Improvement Plans.pdf Markup Summary

Subject: Callout
Page Label: [1] 8 SEWER
Author: Aaron Murg
Date: 2/9/2023 3:01:00 PM
Measurement: 1 Count
Status:
Color: ■
Layer:
Space:

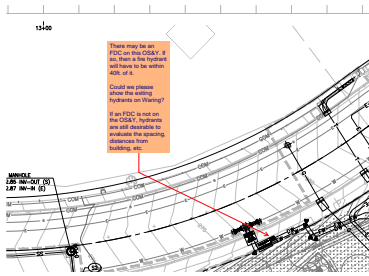
There may be an FDC on this OS&Y. If so, then a fire hydrant will have to be within 40ft. of it.

Could we please show the exiting hydrants on Waring?

If an FDC is not on the OS&Y, hydrants are still desirable to evaluate the spacing, distances from building, etc.
